# UNITED STATES PATENT AND TRADEMARK OFFICE

APPLICATION NO.	FILING DATE	FIRST NAMED INVENTOR	ATTORNEY DOCKET NO.	CONFIRMATION NO.
10/004,758	12/04/2001	Donald J. Monroe	10541-636	8286
29074	7590	08/18/2004	EXAMINER	
VISTEON C/O BRINKS HOFER GILSON & LIONE PO BOX 10395 CHICAGO, IL 60610			RODRIGUEZ, PAMELA	
			ART UNIT	PAPER NUMBER
			3683

# Office Action Summary

## **DETAILED ACTION**

Fig. 1

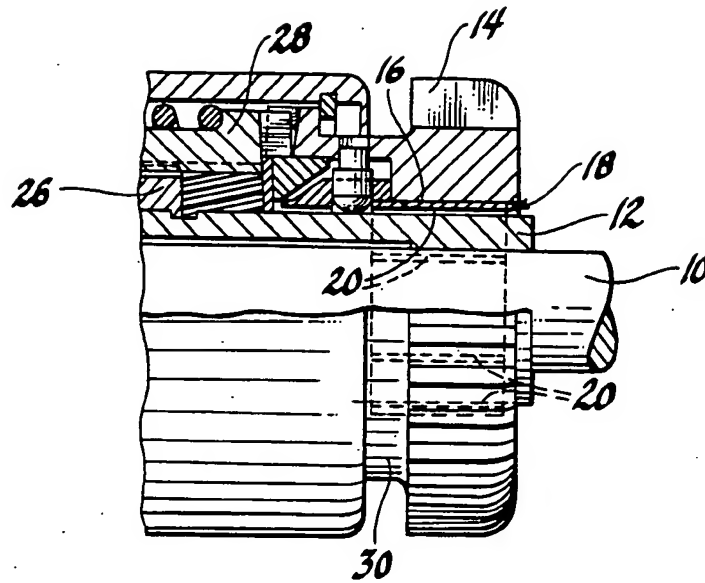
Regarding Claim 1, Johnston discloses a pinion 14/18 moveable along an output shaft 10 of a starter assembly (see Figures 1 and 2) having all the features of the instant invention including: the pinion 14/18 having an inner surface 24 disposed about the output shaft 10 (see the attached labeled Figures 1 and 2 of Johnston and the inner surface portion indicated therein, wherein

since bushing 18 is integral with pinion 14, the inner surface is readable as the inner surface 24 of pinion bushing 18), the inner surface terminating at an end face of the pinion 14/18 (see the examiner's attached labeled Figures 1 and 2 of the Johnston reference depicting the inner surface and the end face as she now interprets them), wherein the inner surface and the end face are perpendicular with each other and define a secondary edge (see the examiner's attached labeled Figures 1 and 2 of Johnston, where the secondary edge is the pink highlighted portion of the figure where the inner surface and end face meet), wherein the pinion 14/18 comprises a primary edge (see Figure 2 and the middle groove 20, wherein the primary edge is readable as the right top edge of that groove nearest the top lead line of element numeral 24) for moving particles from the shaft 10 as the pinion 14/18 moves along the output shaft (see column 3 lines 6-13), the primary edge being formed along a length of the inner surface (see Figure 2) and extending to the end face 22 (see Figure 2), the primary edge defining a groove 20 in which the particles are received as the pinion 14/18 moves along the output shaft (see column 3 lines 6-13), and wherein the groove 20 is formed along the length of the inner surface 24 and adjacent the primary edge (see Figure 2).

Regarding Claim 14, see the barrel portion shown in Figure 1 and a gear portion (see Figure 1 and the portion of pinion 14/18 labeled element numeral 14), wherein the end face and the inner surface 24 are adjacent the gear portion (see Figures 1 and 2).

Fig. 2

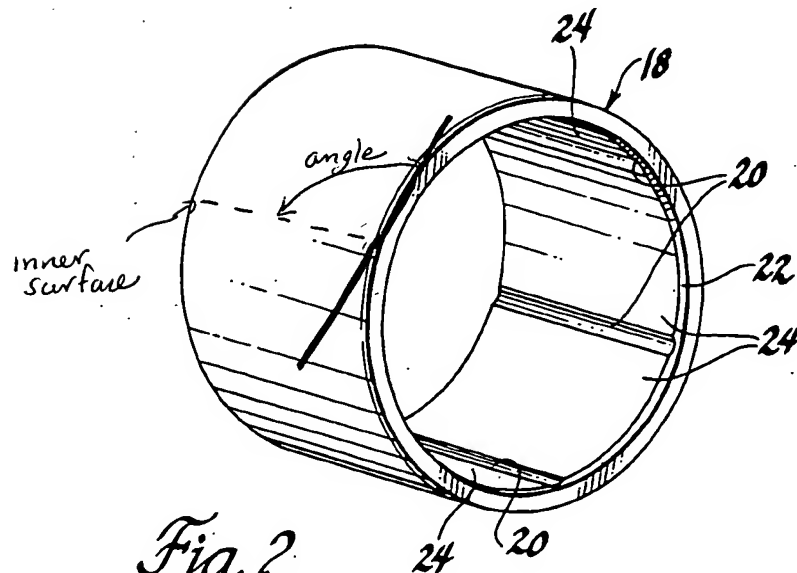
Regarding Claim 5, Johnston further discloses a secondary edge for moving the particles from the primary edge, the secondary edge being defined at the juncture of the end face and the inner surface and being configured to move the particles from the shaft (see the examiner's attached labeled Figures).

Regarding Claim 9, see the plurality of grooves 20 on the inner surface 24 shown in Figure 2 and note how each groove has its own separate primary edge as described in Claim 1 above.

Regarding Claim 10, see grooves 20 in Figure 2, each formed along the length of the inner surface 24 and adjacent each respective primary edge.

the secondary edge would be at least slightly less or equal to 90 degrees (see the examiner's labeled figures).
